**ADDENDUM NUMBER 3**

**PROJECT:** 46 KV Transmission Line – 2024 Modifications & Additions  
City of Fairhope (**BID NO. 25-003**)

**FROM:** Stewart Engineering, Inc.  
PO Box 2233  
Anniston, AL 36202  
(256) 237-0891

This addendum forms a part of the Contract Documents and modifies the original Construction Documents, Drawings and Specifications dated October, 2024 as noted below.

CITY OF FAIRHOPE	
46KV TRANSMISSION LINE - 2024	
MODIFICATIONS & ADDITIONS ALTERNATE #2	
DRAWN BY: ACG	DATE: 10-10-24
APPROVED BY: JLJ	DATE: 10-10-24
DWG#: AX23103-1	STEWART ENGINEERING ELECTRICAL CONSULTANTS ANNISTON, ALABAMA PHONE: (256)237-0891
SHEET: 11 OF 15	SCALE: 1"=50'

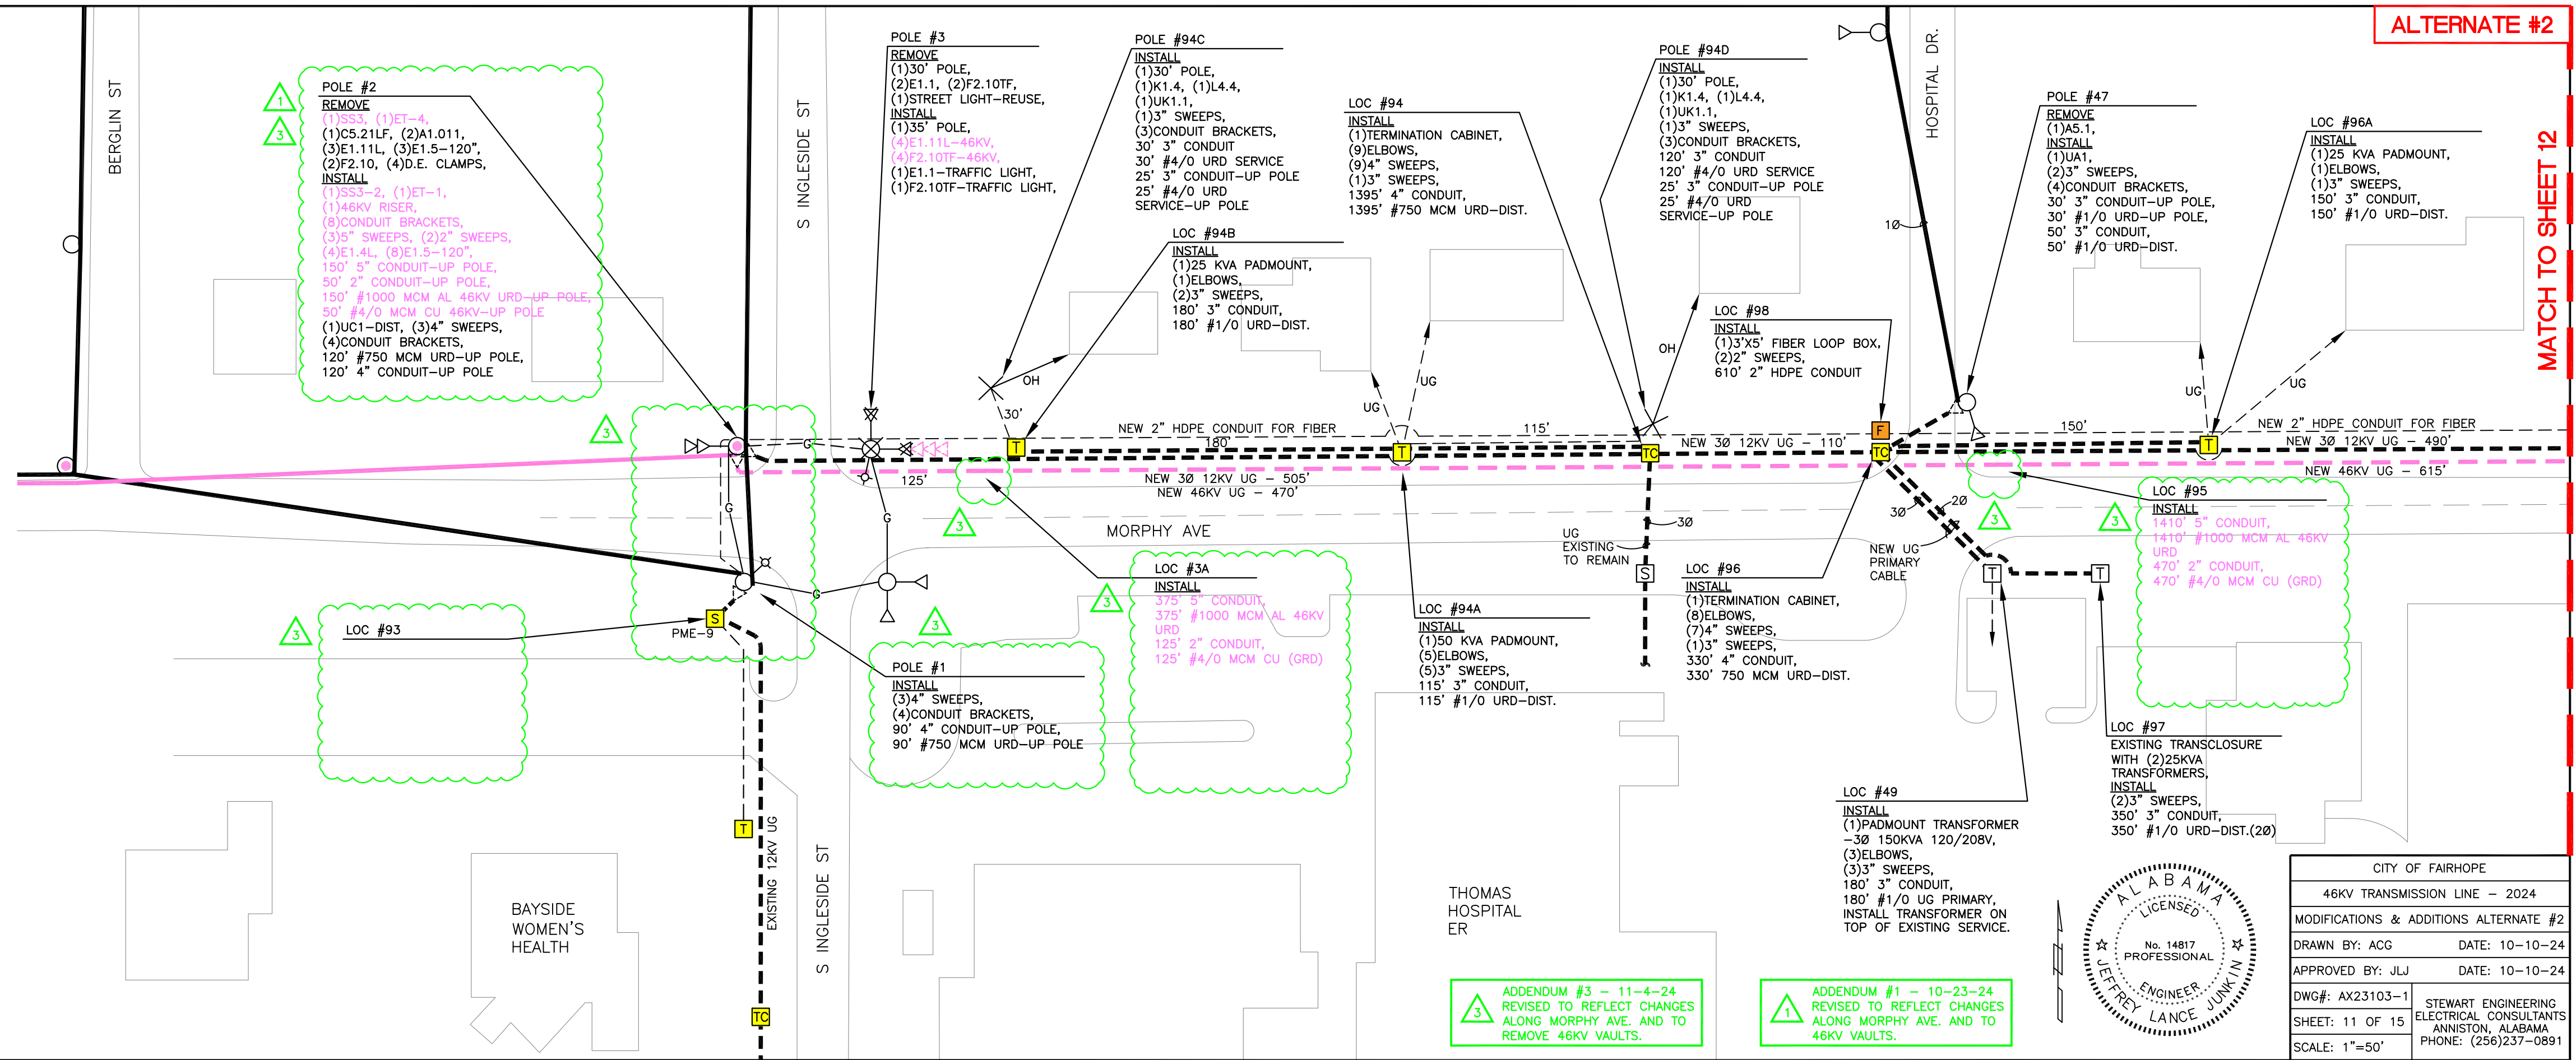
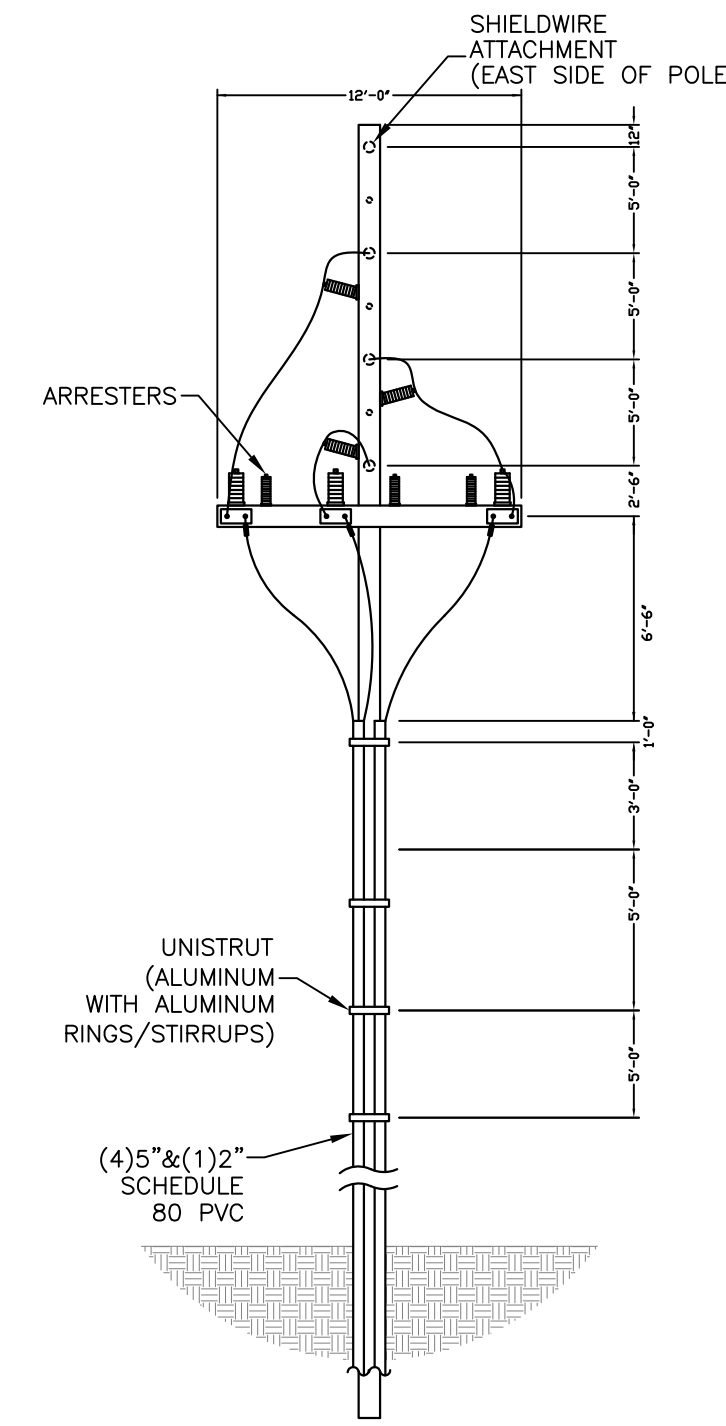
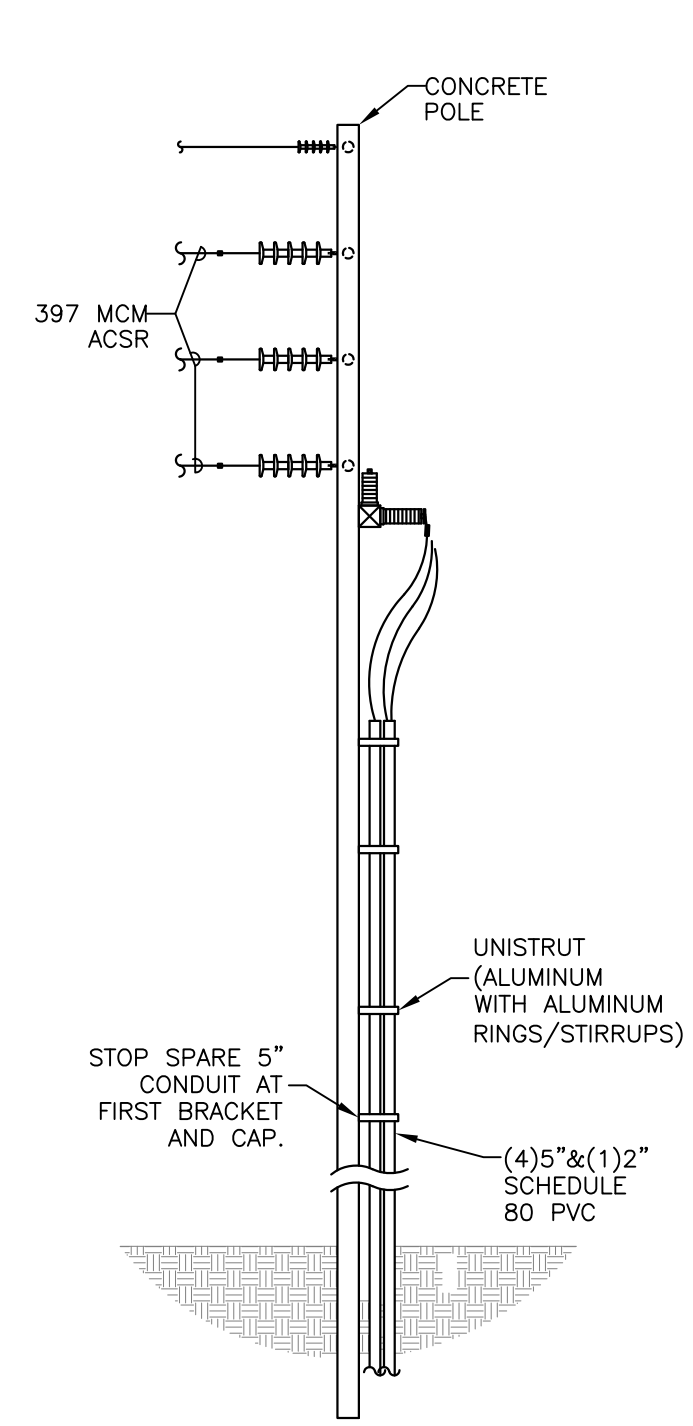
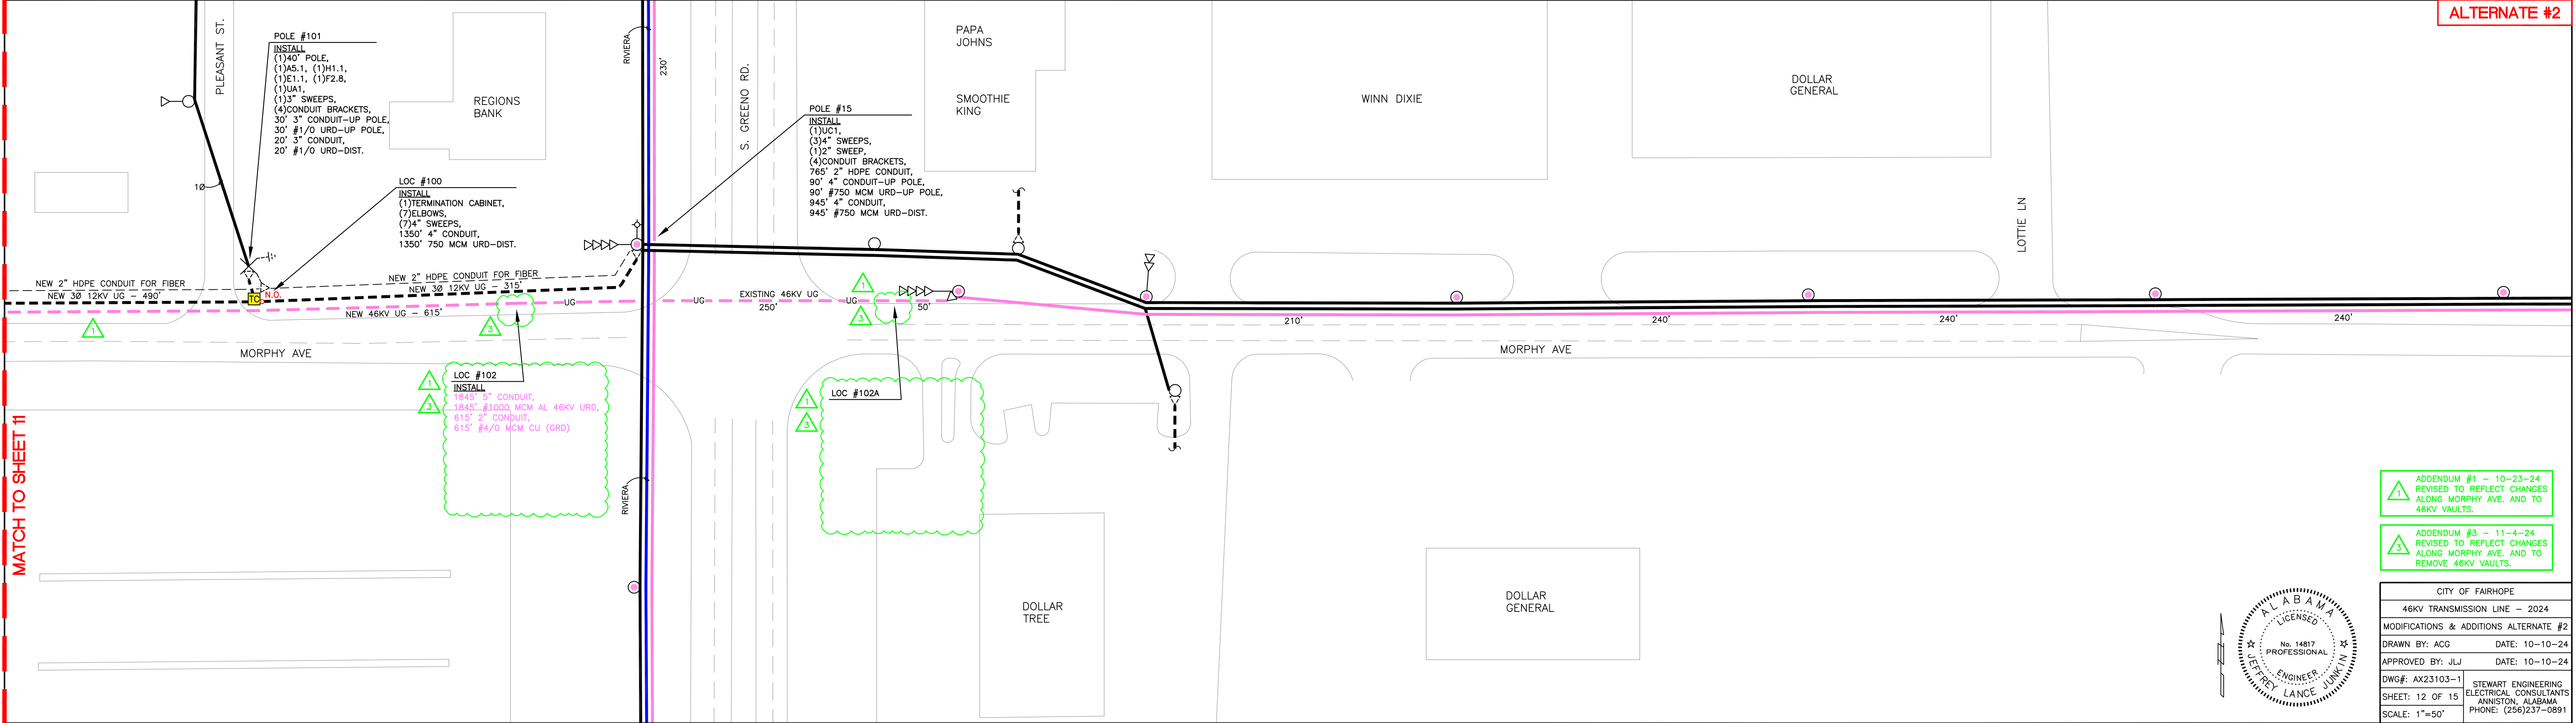
ADDENDUM #3 - 11-4-24  
REVISED TO REFLECT CHANGES  
ALONG MORPHY AVE. AND TO  
REMOVE 46KV VAULTS.

ADDENDUM #1 - 10-23-24  
REVISED TO REFLECT CHANGES  
ALONG MORPHY AVE. AND TO  
46KV VAULTS.

**POLE #2**  
REMOVE  
(1)SS3, (1)ET-4,  
(1)C5.21LF, (2)A1.011,  
(3)E1.11L, (3)E1.5-120",  
(2)F2.10, (4)D.E. CLAMPS,  
INSTALL  
(1)SS3-2, (1)ET-1,  
(1)46KV RISER,  
(8)CONDUIT BRACKETS,  
(3)5" SWEEPS, (2)2" SWEEPS,  
(4)E1.4L, (8)E1.5-120",  
150' 5" CONDUIT-UP POLE,  
50' 2" CONDUIT-UP POLE,  
150' #1000 MCM AL 46KV URD-UP POLE,  
50' #4/0 MCM CU 46KV-UP POLE  
(1)UC1-DIST, (3)4" SWEEPS,  
(4)CONDUIT BRACKETS,  
120' #750 MCM URD-UP POLE,  
120' 4" CONDUIT-UP POLE

**POLE #3**  
REMOVE  
(1)30' POLE,  
(2)E1.1, (2)F2.10TF,  
(1)STREET LIGHT-REUSE,  
INSTALL  
(1)35' POLE,  
(1)E1.1-TRAFFIC LIGHT,  
(1)F2.10TF-TRAFFIC LIGHT,

**POLE #94C**  
INSTALL  
(1)30' POLE,  
(1)K1.4, (1)L4.4,  
(1)UK1.1,  
(1)3" SWEEPS,  
(3)CONDUIT BRACKETS,  
30' 3" CONDUIT  
30' #4/0 URD SERVICE  
25' 3" CONDUIT-UP POLE  
25' #4/0 URD  
SERVICE-UP POLE

**LOC #94**  
INSTALL  
(1)TERMINATION CABINET,  
(9)ELBOWS,  
(9)4" SWEEPS,  
(1)3" SWEEPS,  
1395' 4" CONDUIT,  
1395' #750 MCM URD-DIST.

**POLE #94D**  
INSTALL  
(1)30' POLE,  
(1)K1.4, (1)L4.4,  
(1)UK1.1,  
(1)3" SWEEPS,  
(3)CONDUIT BRACKETS,  
120' 3" CONDUIT  
120' #4/0 URD SERVICE  
25' 3" CONDUIT-UP POLE  
25' #4/0 URD  
SERVICE-UP POLE

**POLE #47**  
REMOVE  
(1)A5.1,  
INSTALL  
(1)UA1,  
(2)3" SWEEPS,  
(4)CONDUIT BRACKETS,  
30' 3" CONDUIT-UP POLE,  
30' #1/0 URD-UP POLE,  
50' 3" CONDUIT,  
50' #1/0 URD-DIST.

CITY OF FAIRHOPE	
46KV TRANSMISSION LINE - 2024	
MODIFICATIONS & ADDITIONS ALTERNATE #2	
DRAWN BY: ACG	DATE: 10-10-24
APPROVED BY: JLJ	DATE: 10-10-24
DWG#: AX23103-1	STEWART ENGINEERING
SHEET: 13 OF 15	ELECTRICAL CONSULTANTS
SCALE: AS NOTED	ANNISTON, ALABAMA
	PHONE: (256)237-0891

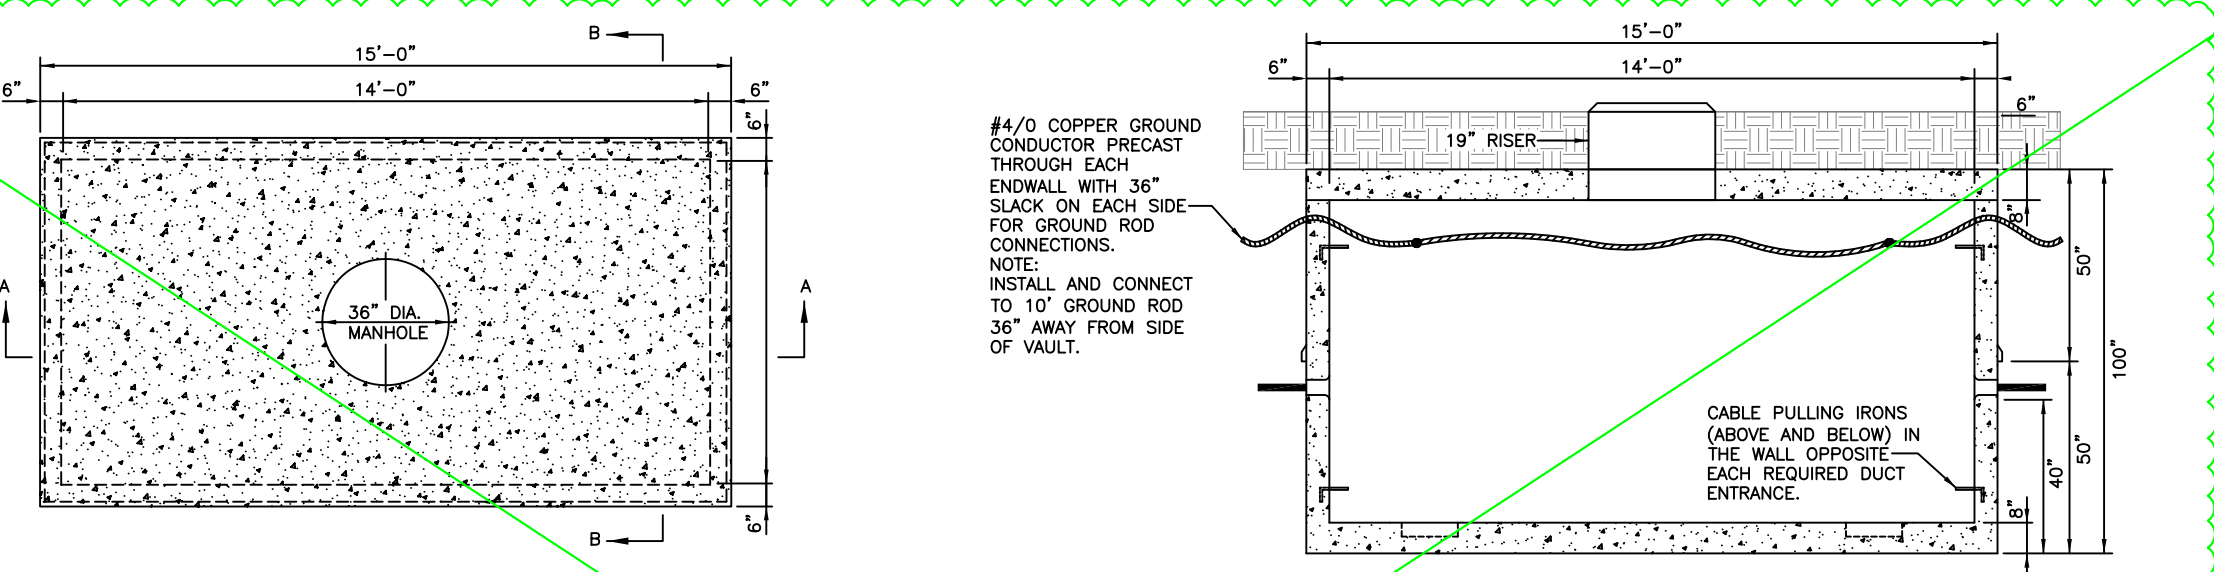
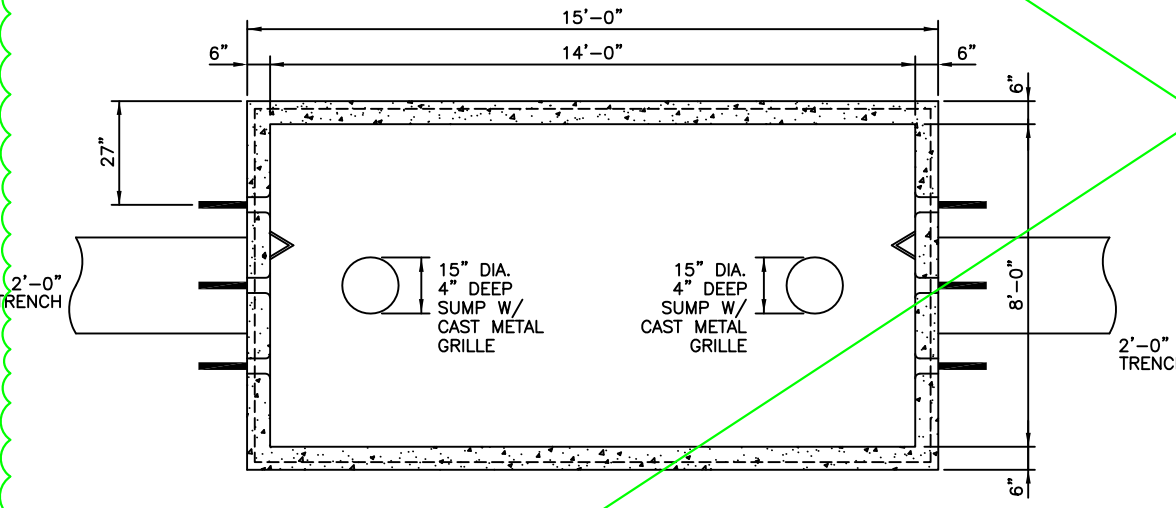
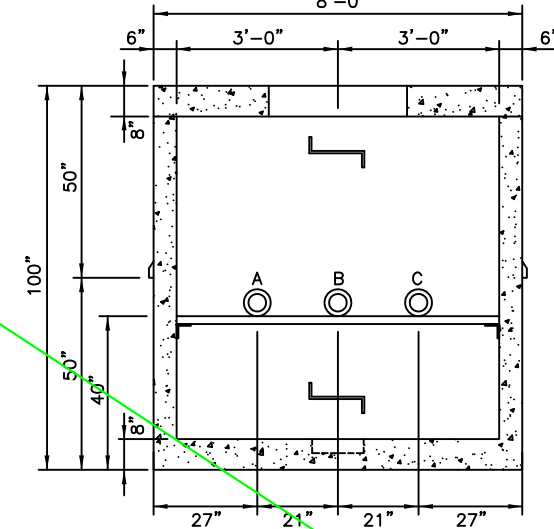
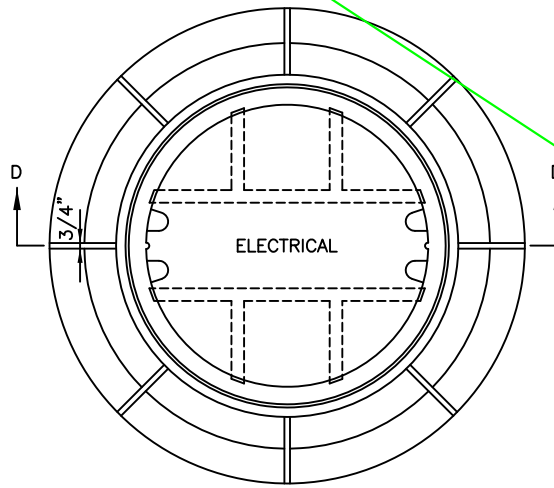
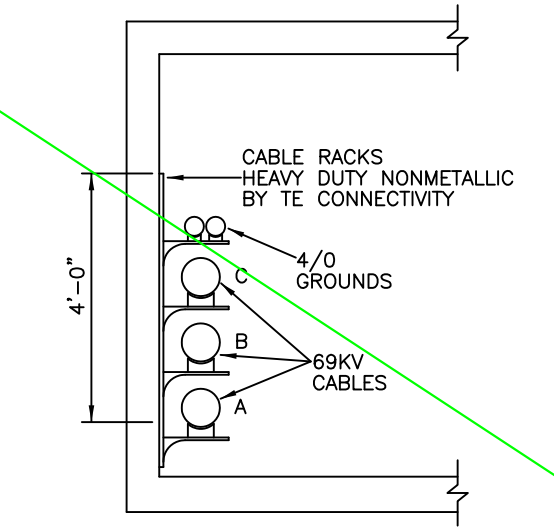
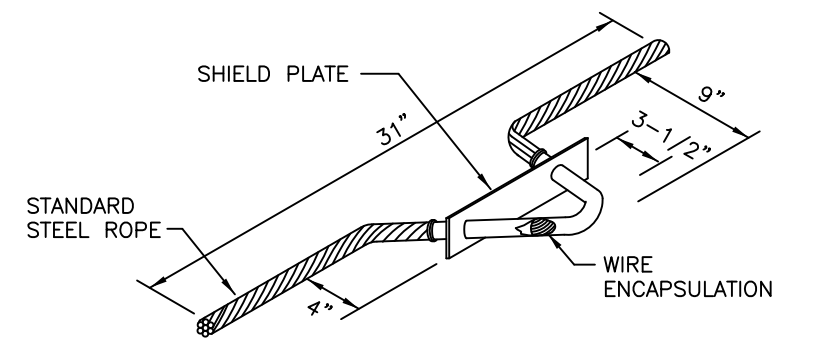
**1** ADDENDUM #1 - 10-23-24  
REVISED TO REFLECT CHANGES ALONG MORPHY AVE. AND TO 46KV VAULTS.

**3** ADDENDUM #3 - 11-4-24  
REVISED TO REFLECT CHANGES ALONG MORPHY AVE. AND TO REMOVE 46KV VAULTS.

#4/0 COPPER GROUND CONDUCTOR PRECAST THROUGH EACH ENDWALL WITH 36" SLACK ON EACH SIDE FOR GROUND ROD CONNECTIONS.  
NOTE: INSTALL AND CONNECT TO 10' GROUND ROD 36" AWAY FROM SIDE OF VAULT.

CABLE PULLING IRONS (ABOVE AND BELOW) IN THE WALL OPPOSITE EACH REQUIRED DUCT ENTRANCE.

1. AT ALL MANHOLES, CONNECT THE TWO MANHOLE 4/0 COPPER GROUND TAILS TO EACH OTHER WITH 4/0 COPPER (COMPRESSION CONNECTIONS).
2. AT ALL MANHOLES, CONNECT THE INCOMING 4/0 COPPER GROUND CONDUCTOR (CONDUIT G) TO THE OUTGOING 4/0 COPPER GROUND CONDUCTOR (CONDUIT G) WITH COMPRESSION CONNECTORS.
3. AT ALL MANHOLES, MAKE A 4/0 COPPER CONNECTION BETWEEN THE MANHOLE 4/0 COPPER GROUND TAIL LOOP AND THE INCOMING COPPER GROUND CONDUCTOR LOOP, USING COMPRESSION CONNECTORS.
